## LiDAR Quality Assessment Report

UT\_Ogden-FEMA

LiDAR generated point cloud acquired in October 2011 for a 116-square mile area encompassing Ogden UT.

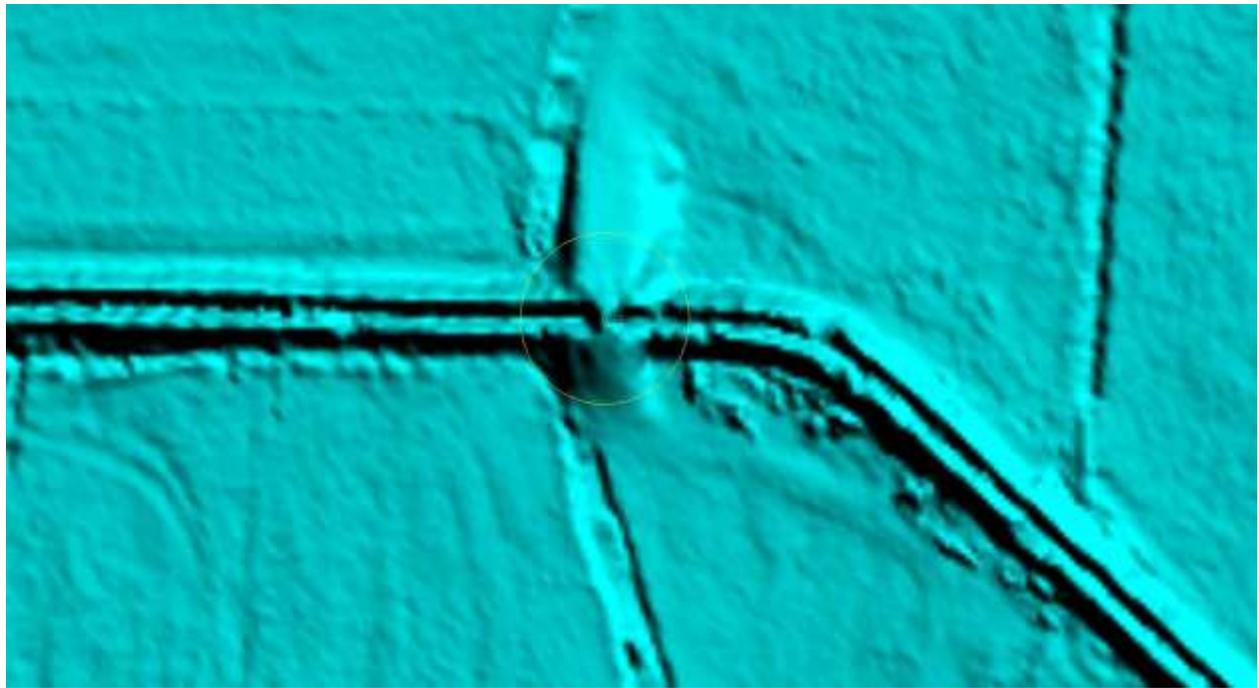
Rail road not fixed by the contractor

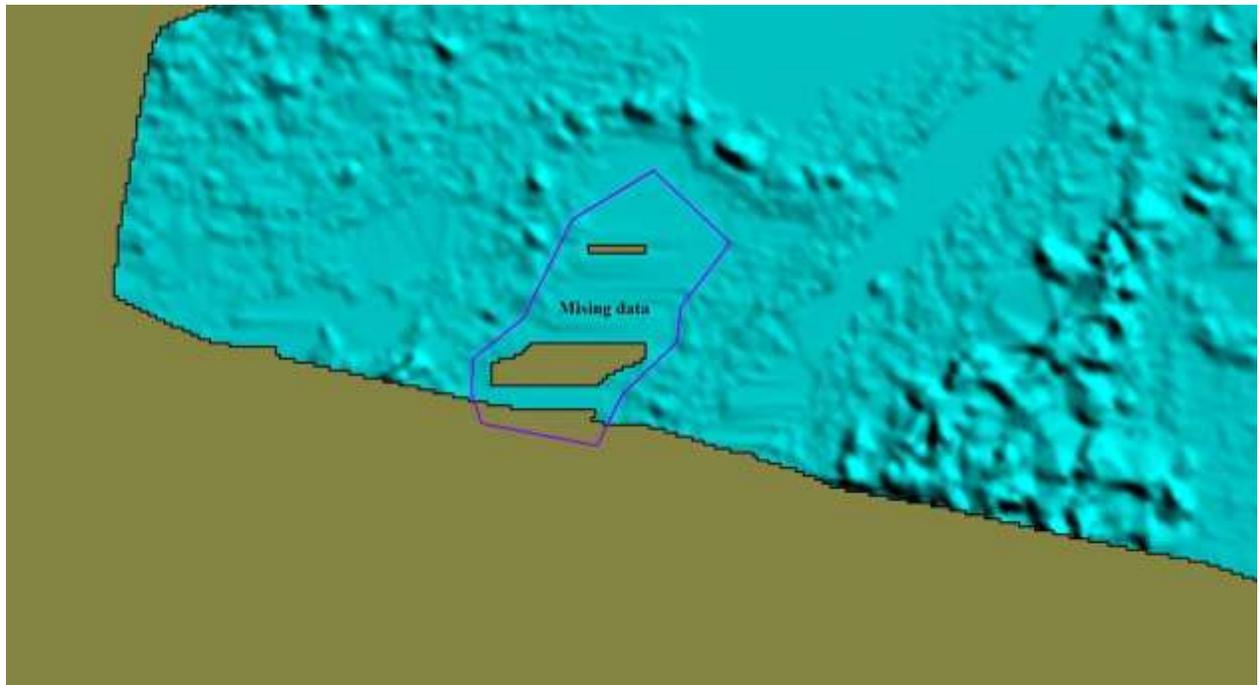
Road not fixed by the contractor

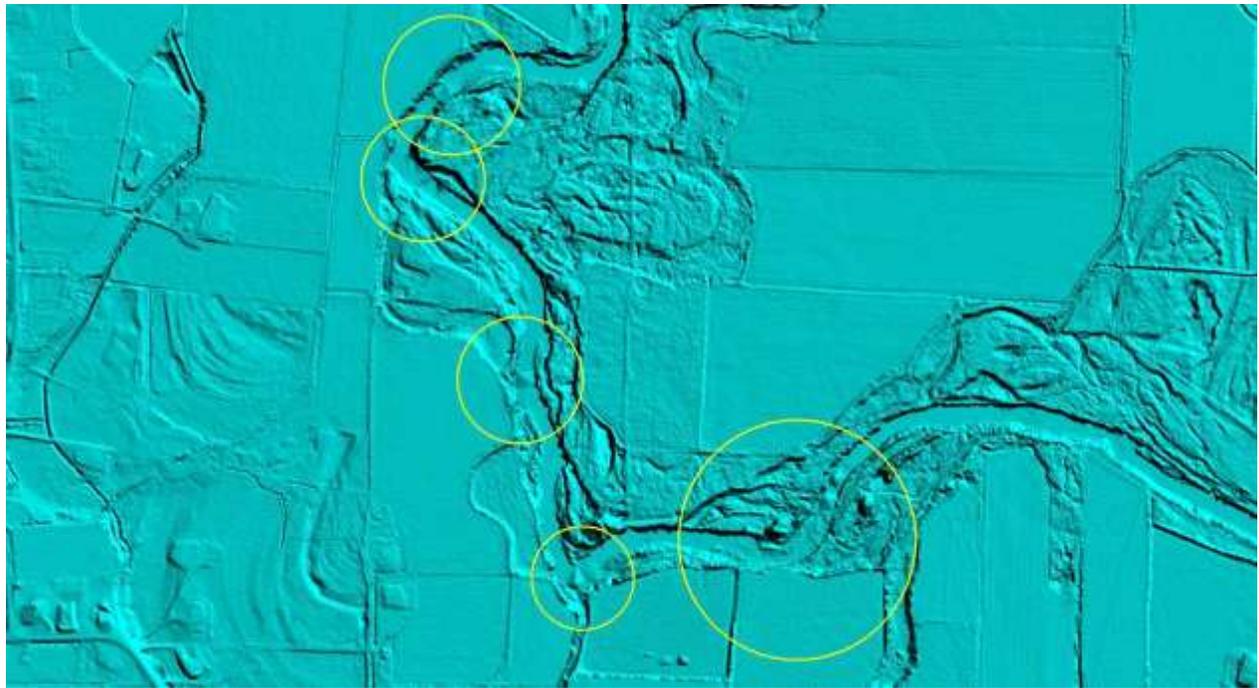
Missing data not fixed by the contractor

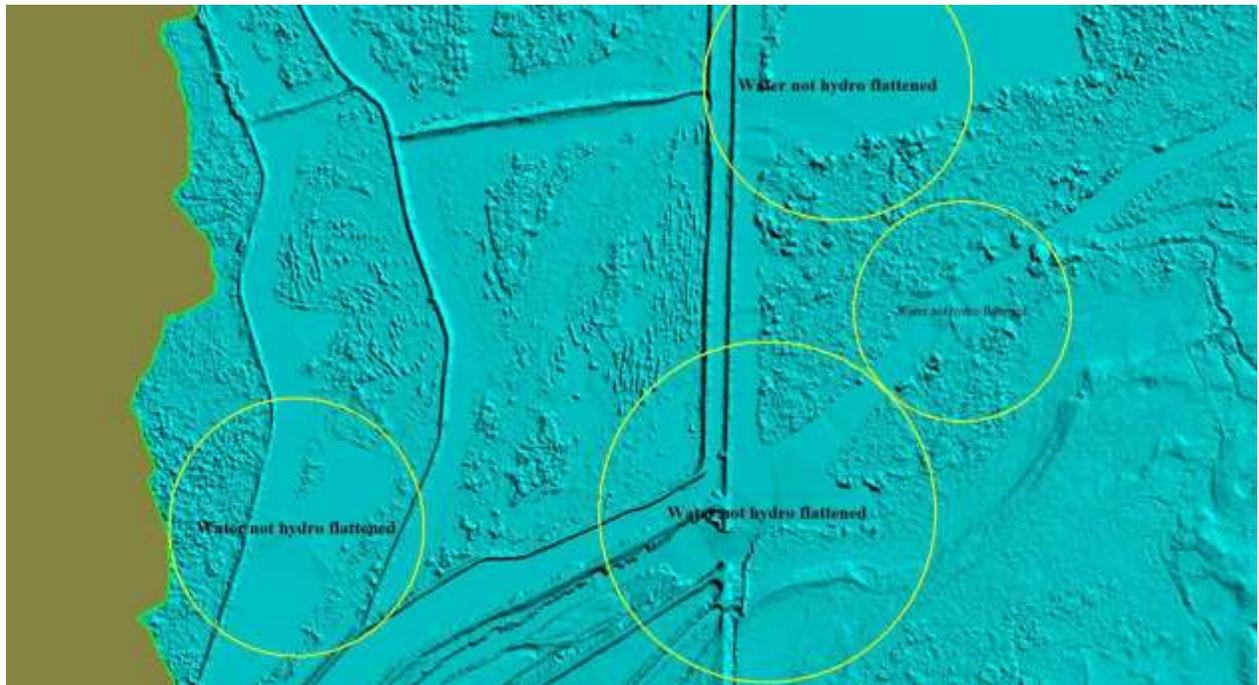
River errors fixed by the contractor
